REPORT TO THE COMMITTEE OF ADJUSTMENT & PLANNING ADVISORY COMMITTEE	
Date of Report: July 16, 2024	Date of Meeting: July 24, 2024
Subject of Report: Section 45 Application A-14-2024 & Site Plan Control Application SP-26-2024 COURVILLE	
Recommendation: Staff recommend that the Section 45 application A-14-2024 be deferred for the following reasons: <ol style="list-style-type: none"> 1. To provide more time to examine alternative dwelling layouts and sizing with the applicants that result in a maximized water setback; 2. To allow for more time for staff to work with the preparers of the submitted EIS to address the significance of adjacent woodland designations and any potential impacts to the woodlands resulting from the proposed development, and a determination of the water setback from the proposed dwelling to the unevaluated wetland on site. Should the setback be less than 6m which was included in the notice, a re-notice or amendment to the application is required; 3. That the amended EIS receive a peer review that is completed by a qualified firm to the satisfaction of the Manager of Development Services. The cost associated to the peer review shall be recovered by the Township f

Figure 5 – Site Plan Drawing

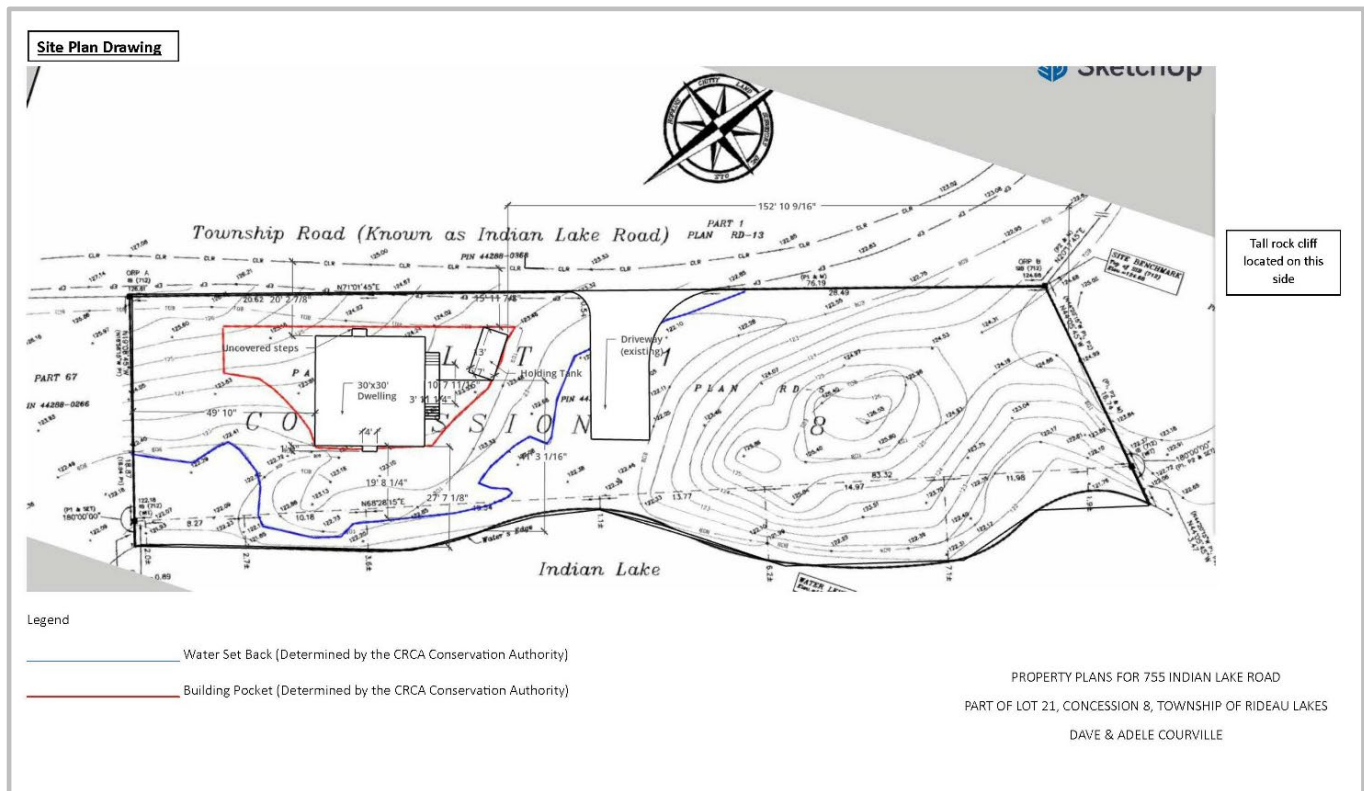
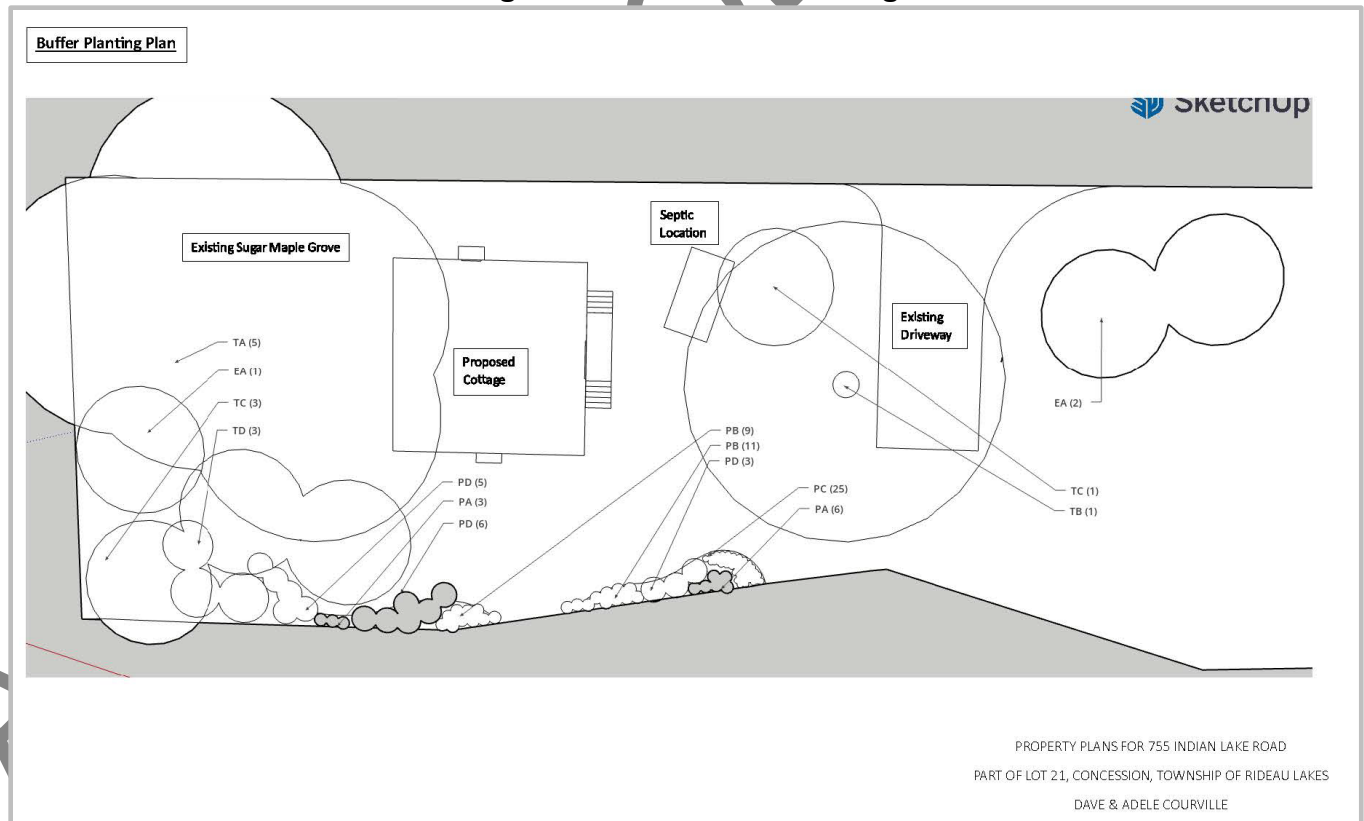
The application form identified a setback of 12.6m from the water for the proposed sewage disposal system, and an 8.4m water setback for the dwelling, however, upon further review staff understood the setback of the sewage disposal system and dwelling to be approximately 6m, based on the blue contour line noted on the submitted site plan which represents the maximum recorded water of Indian Lake. Therefore, staff noticed the anticipated 6m setback for the proposed sewage disposal system and dwelling in the public notice of the application.

The provided site plan and dimensions to the water did not account for the identified unevaluated wetland in the submitted EIS. As such, staff recommend that the application be deferred so that the water setback can be properly evaluated when accounting for the unevaluated wetland identified in the EIS, and an updated water setback is provided accordingly. Should the revised proposal result in a setback of less than 6m for either the sewage disposal system or dwelling, the application would require a re-notice. In addition to the above measures, staff are also recommending that the applicant re-evaluate the proposed dwelling size and layout to further demonstrate a maximized setback. The proposed dwelling is an approximate 30ft x 30ft structure that maintains an approximate 50ft setback to the western lot line, and the submitted sketch identifies an envelope that has more land to the west that some of the dwelling area could occupy that is further than 6m from the water. Staff believe that this area should be examined for some of the dwelling to be located, in order to increase the dwelling's setback to the water. As a result of the comments from the Roads Manager, as well as the potential ability to explore alternative dwelling designs to maximize the setback on the lot, staff are recommending deferral in order to achieve a maximized water setback in order to meet the intent of the Zoning By-law.
